Access Compliance Report

Public Rights-of-Way

(Curb Ramps)

Intersection ID: 10031812	Main Street: MILLENNIUM_AV	Cross Street: AUDUBON_PARK_DR	Location:	N
ADA ID: 4E8628AE21A0	Ramp Type: Directional1	Initial Pass/Fail: Pass	Overall Compliance: No	Severity Score: 0
Codes/Mitigation Info/Possible Solution		Field Measurements/Component Compliance

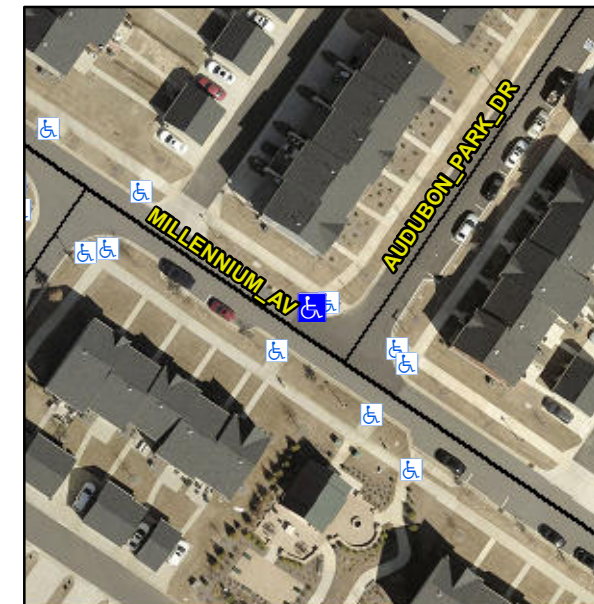
Remove & Replace Detectable Warning System. Remove & Replace Gutter.

R305.2, R304.5.3
